# Access Compliance Report

## Public Rights-of-Way

### (Pedestrian Signals)

| ADA ID: 9BF4758AE410                    | Signal Type: Two Push Buttons-APS | Overall Compliance: No                  | Severity Score: BTN 1:N/A BTN 2: N/A No BTN: N/A |

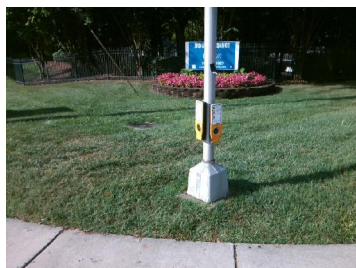
| Compliance | Description                             | Data    | Compliance | Description                            | Data |
|------------|-----------------------------------------|---------|------------|----------------------------------------|------|
| No         | B 1 Clear Floor Space XSlope (%)        | 7.4     | No         | B 2 Clear Floor Space XSlope (%)       | 8.9  |

| No  | B 1 DistanceTo Curb (in)  | 82.0          | No  | B 2 DistanceTo Curb (in)  | 82.0          |

| Is Button 1 APS or Non-APS?         | APS | Is Button 2 APS or Non-APS?         | APS |
|-------------------------------------|-----|-------------------------------------|-----|
| No B 1 Percussive Walk Cycle?       | Yes | No B 2 Percussive Walk Cycle?       | Yes |

Possible Solutions: Replace Signal Push Button With APS Button on New Post. Remove & Relocate Sign.

PROW/ADA: TMUTCD 4e.08, R404.2, R406.2, R404.7.3,
